SUSTAINABLE DEVELOPMENT – URBAN DESIGN & PLANNING PLANNING & ZONING BOARD (PZB) SITE PLAN APPLICATION

Site Plan Application

Development / Project Name	1007 EAST LAS OLAS
Development / Project Address	Existing: see address verification New: 1007 E. LAS OLAS BLVD.
Legal Description	see survey
Tax ID Folio Numbers (For all parcels in development)	5042 11 01 0750; 5042 11 01 0760; 5042 11 01 0640
Request / Description of Project	HOTEL DEVELOPMENT (138 rooms; 5,963sf commercial/retail)
Applicable ULDR Sections	Sec. 47-25.3, Sec. 47-28; Sec. 47-20.3.A.5
Total Estimated Cost of Project	\$ 25m (Including land costs)

Figure 2 – City Sewer Atlas

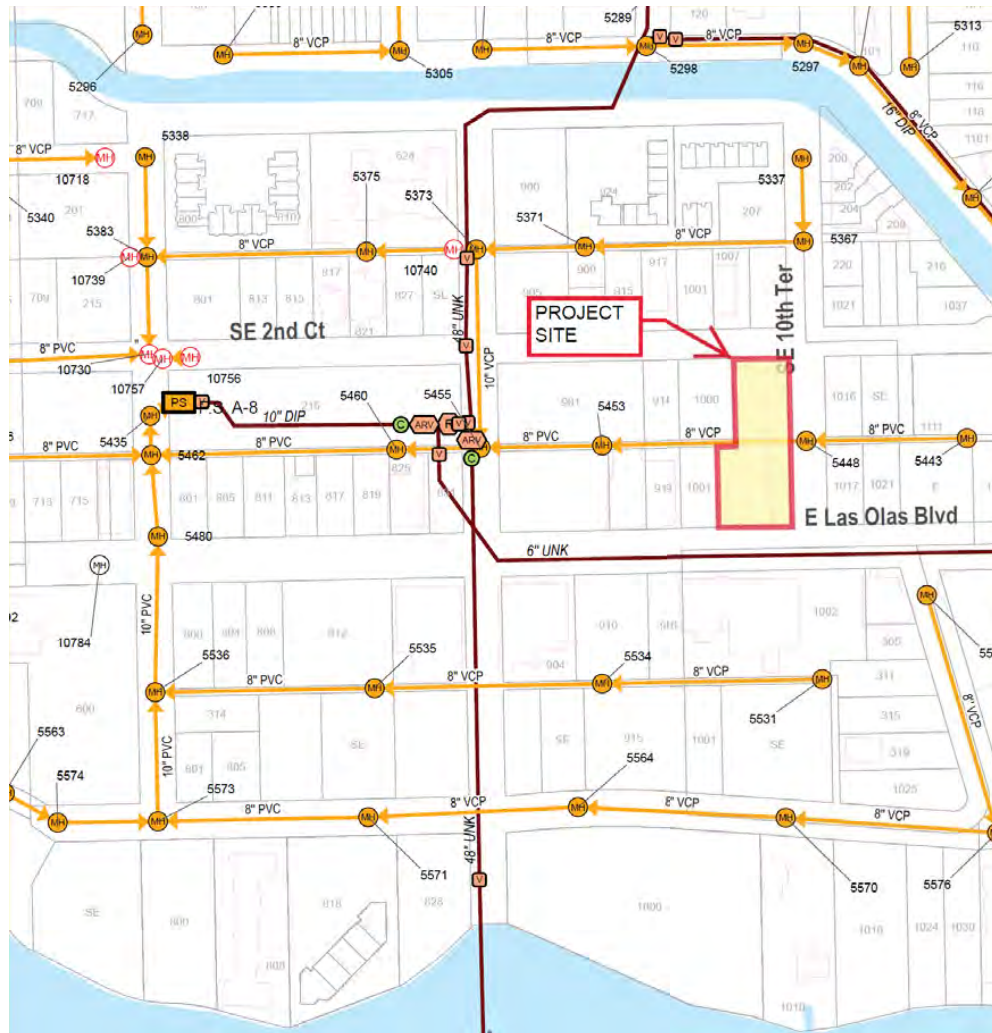
Wastewater: The site is currently served by an existing 8-inch gravity sewer main along the 10' Alley crossing the proposed project site from east to west (See Figure 2).

The existing water and sewer infrastructure has sufficient capacity to serve the project with no improvements required.

Figure 3

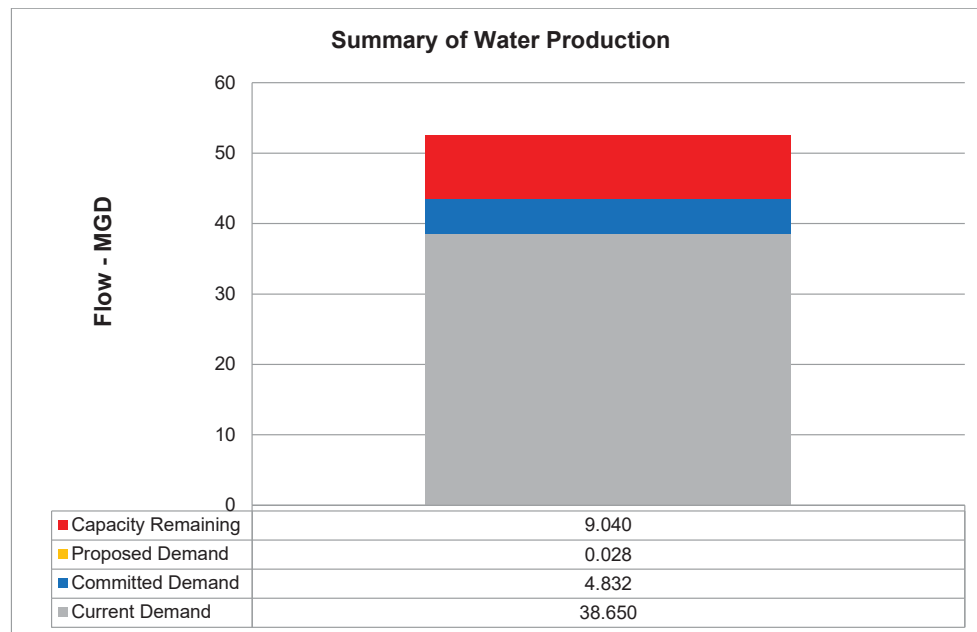
The current twelve-month rolling average production at the two plants is 38.65 MGD. The previously committed demand from development projects in the permitting or the construction stage is 4.832 MGD. Combining these figures with the demand from the proposed project of 0.028 MGD, the required production would be 43.51 MGD. This is less than the allowable withdrawal limit of 52.55 MGD. Therefore, the water plants have sufficient capacity to serve this project. See Figure 3 below.

Recommended Water Infrastructure Improvements: No improvements required.

Figure 4

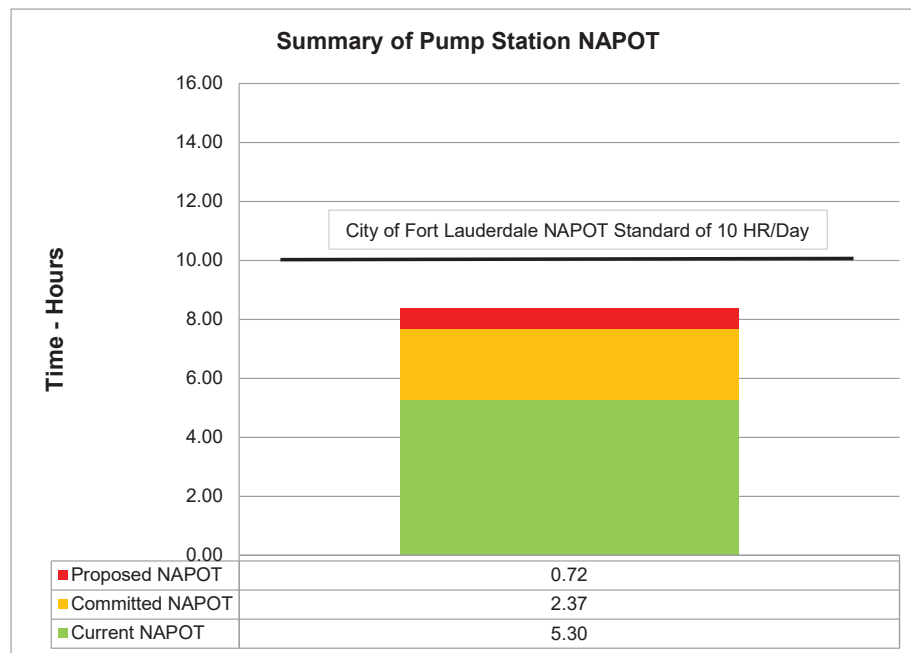
Evaluation of impact on pumping station: PS A-8 has a duty point of 500 gallons per minute (GPM) and has a Nominal Average Pumping Operating Time (NAPOT) of approximately 5.3 hours per day. Based on projected sewage flows, the pumping run times would increase approximately 43 minutes per day. Additionally, there are other committed flows from proposed developments within the PS A-8 basin resulting in approximately 142 minutes of additional runtime at the pump's minimum operating condition. PS A-8 will have a NAPOT of 8.38 hours once the proposed development is completed, less than the recommended average of 10 hours per day (see Figure 4).

Figure 5

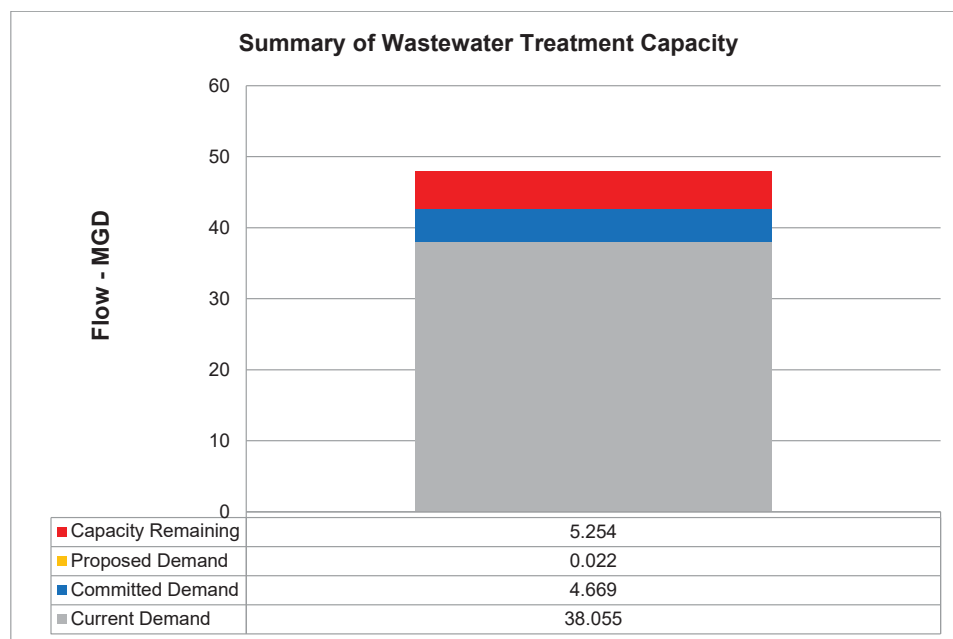
Evaluation of impact of Permitted Wastewater Plant Capacity: The City of Fort Lauderdale owns and operates the George T. Lohmeyer Regional Wastewater Treatment Plant (GTL), which provides wastewater treatment for the City of Fort Lauderdale. The Broward County's Environmental Protection and Growth Management Department's (EPGMD) Environmental Licensing & Building Permitting Division's licensed capacity for GTL is 48 MGD-AADF (Million Gallons per Day – Annual Average Daily Flow). The annual average daily flow (AADF) to the plant is 38.055 MGD. Combining the committed flows for previously approved projects of 4.669 MGD plus the 0.022 MGD net contribution from the project results in a total projected flow of 42.75 MGD. This is less than the permitted treatment plant capacity of 48 MGD. Therefore, the treatment plant has sufficient capacity to serve this project. See Figure 5 below.

Recommended Wastewater Infrastructure Improvements: No improvements required.
